Subdivision	Name: SHAMBLEY MEADOWS PHASE 4
Submit the	following with this application:
	30 paper copies (folded) of Plat showing proposed subdivision (minimum size 18" x 24") See Section 6.1 of Subdivision Regulation for information required to be on Plat 1 digital copy of all documents conforming to Digital Document Submission Guideline 1 Reduced copy of plat (8.5" x 11") List (I copy) of adjoining property owners with mailing addresses. List must include all
<u> </u>	adjoining property owners within 400 feet of property boundaries. A Microsoft Excel spreadsheet listing the names and addresses shall be submitted with the digital submission.
Submit two	(2) paper copies and one (1) digital copy of the following:
X	Stormwater Plan (Contact Fred Royal, Environmental Resource Director, 919-542-8268) Erosion Control Plan (Contact Jim Willis, Erosion Control Inspector, 919-545-8343) Water Utility Plan (Contact Roy Lowder, Chatham Co. Utilities Director, 919-542-8238)

Shambley Meadows Phase IV Subdivision

After evaluating the forms submitted for the Shambley Meadows Phase IV Subdivision, the Environmental Review Board has some concerns. The ERB recognizes that the proposed subdivision f

ATTACHMENT A

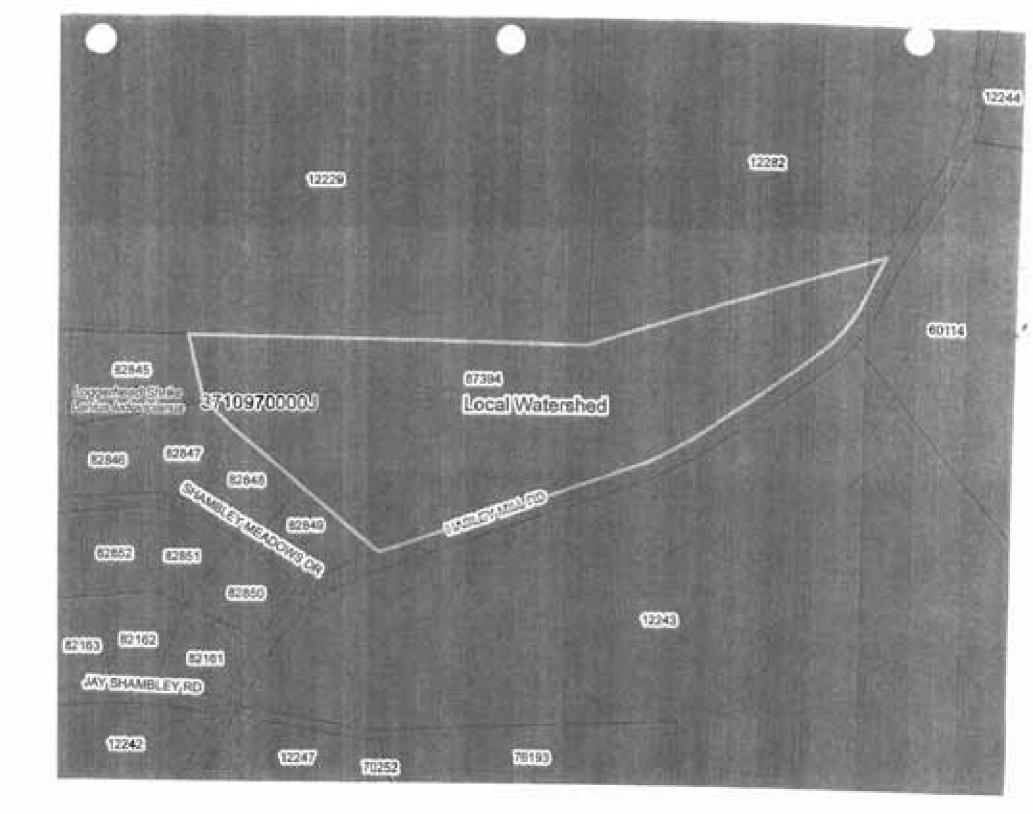
• The small map provided seems to indicate the presence of north-facing slopes, 15% or greater, especially in proposed lots 6, 7, 8, 9 and 10. Such slopes are often home to unique and rich botanical and animal communities that should ideally be preserved, especially, as is the case here, when a perennial stream is located at the bottom of the hill.

- Even steeper north-facing slopes appear to be present in proposed lots 4 and 5.
 Again, the ERB recommends that no ground-disturbing activities be conducted on those slopes.
- Because the majority of proposed lots are strongly sloped, the ERB recommends
 that the applicant pay special attention to the placement and installation of septic
 fields, so that erosion is minimized, and to ensure that sewage does not
 contaminate the perennial stream at the bottom of the slopes.

The proposed public road appears to run straight downslope, which would seem likely to maximize runoff. The ERB recommends that the applicant work closely with the Chatham County Erosion Control Officer to ensure that bestmanagement practices (BMPs) are used to ensure minimization of runoff, and that stormwater best management practices are implemented to avoid scour at the discharge point.

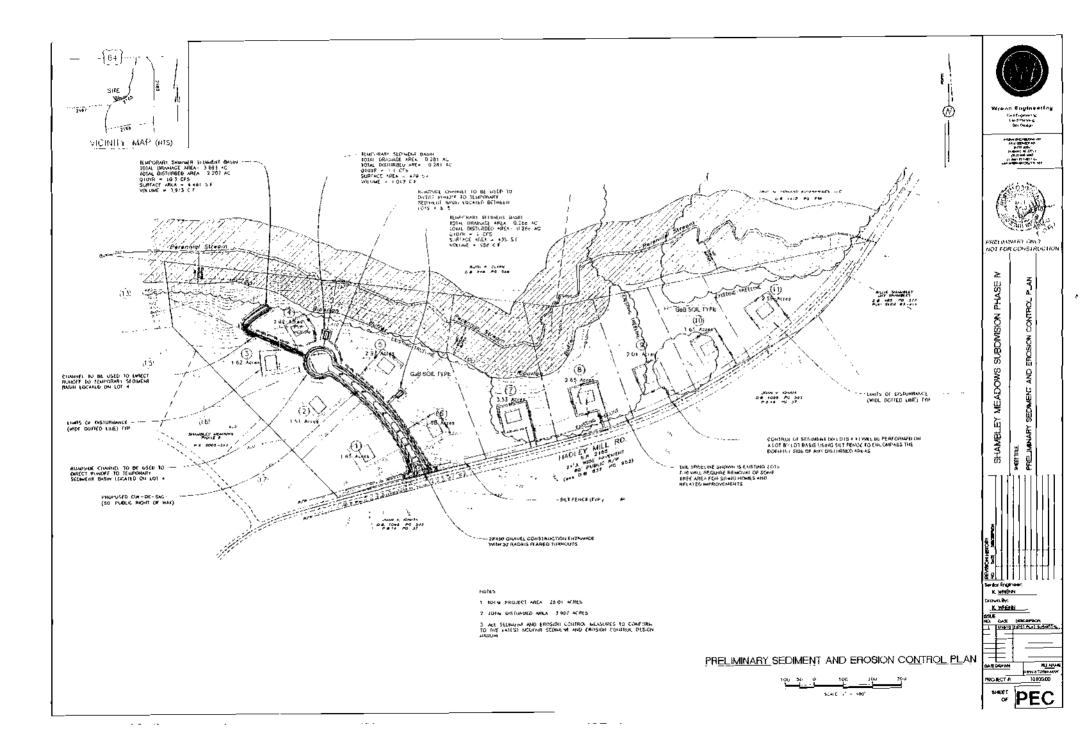
I have reviewed the attached soil erosion and sedimentation control (SESC) preliminary plan for the Shambley Meadows Subdivision Phase IV. The concept of the plan is sufficient for erosion and sediment control. A more complete review of design criteria and detail specifications will be conducted when a full application is made for SESC plan approval and a land disturbing permit.
